Submissions Report

STATE SIGNIFICANT DEVELOPMENT SSD-6026

Milk Processing Facility

111-113 Quarry Road, Erskine Park

DETAIL SURVEY

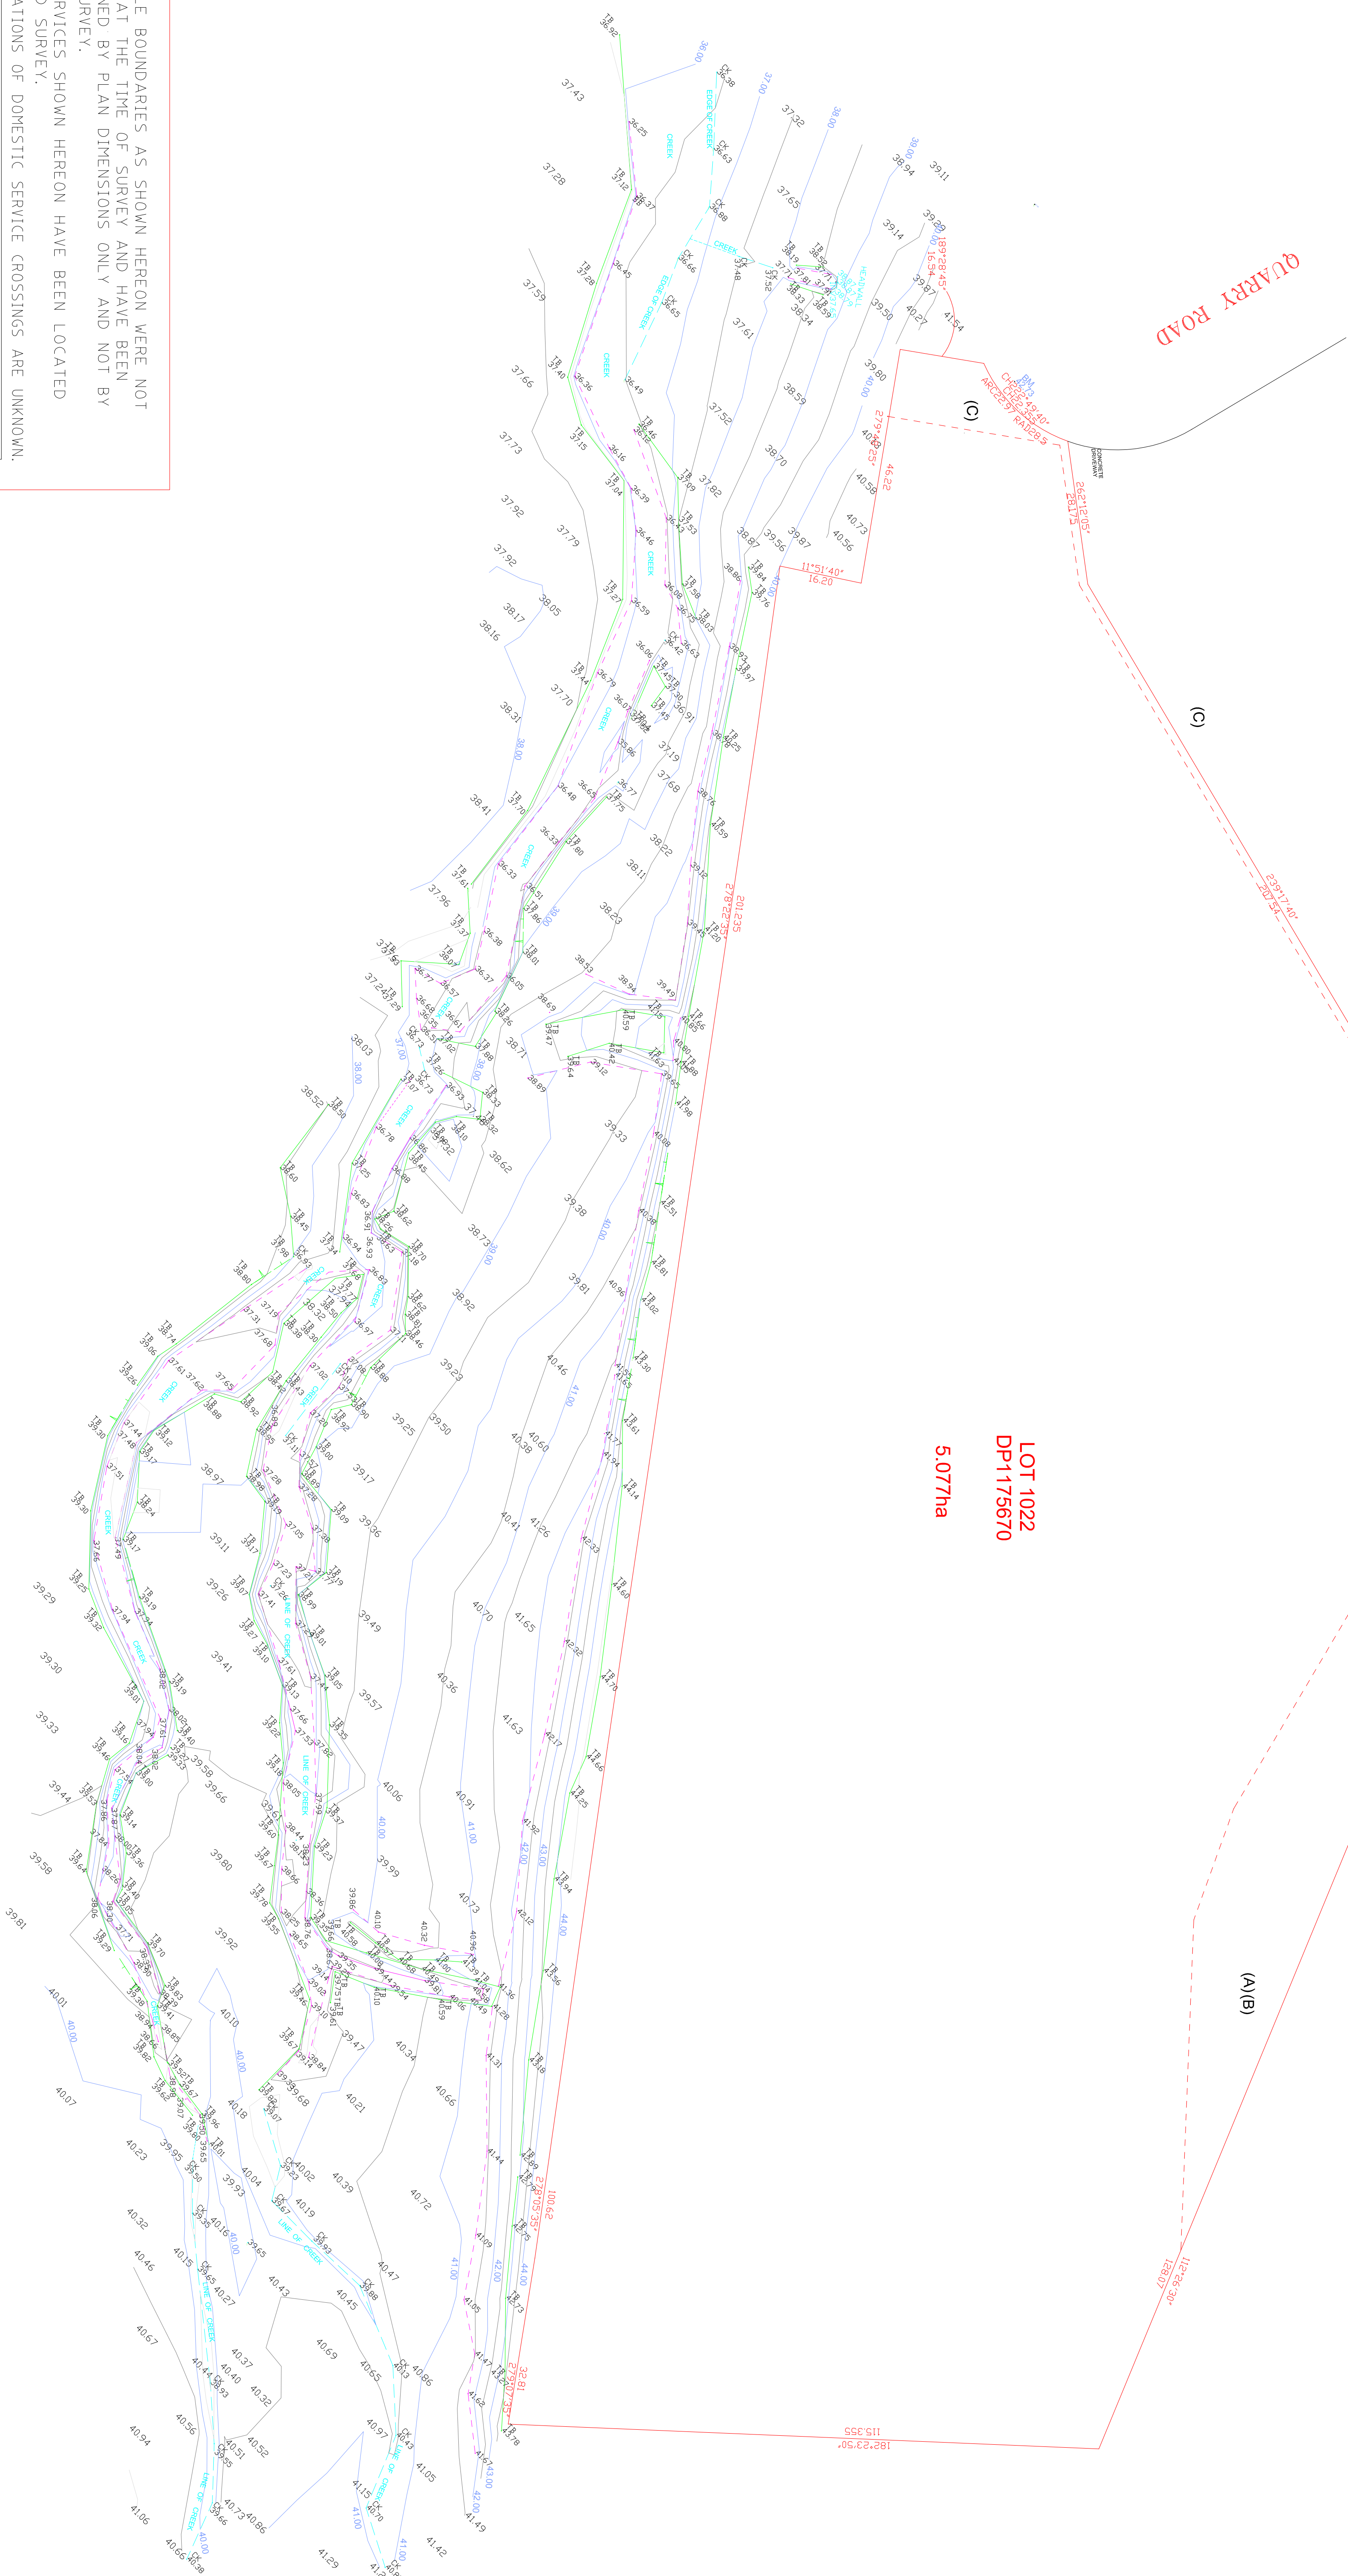
| Issues | Responses |
|--|--|
| <p>Appendix 3 of Technical Paper TP3 notes the stormwater outlet location is within cleared lands and River-Flat Eucalypt Forest (page 34). The Office of Water recommends the following:</p> <ul style="list-style-type: none"> The stormwater outlet structure placed to avoid disturbing remnant native vegetation. A scaled plan, which shows the location of: <ul style="list-style-type: none"> The proposed stormwater structure route. The creek and top of the bank. The boundary of the Biodiversity Corridor. Remnant vegetation potentially affected by the outlet structure. | <p>The preferred stormwater discharge option involves connection to the existing Council drainage network and would involve no disturbance or activities in waterfront land (refer to Appendix 2). Council is yet to authorize this option, so the fallback option is to construct a new outlet.</p> <p>The new outlet structure would be located near the existing Council outlet and would involve only minimal clearing of native vegetation within the River Flat Eucalypt Forest, as shown in Appendix 3. The vegetation likely to be disturbed is relatively young regrowth. The new outlet structure would be primarily located in a grass strip area as shown in Appendix 3.</p> <p>Appendix 2 indicates the stormwater structure route and the boundary of the biodiversity corridor. The impact on remnant vegetation is described above and illustrated in Appendix 3. Appendix 4 provides a survey of the creek.</p> |
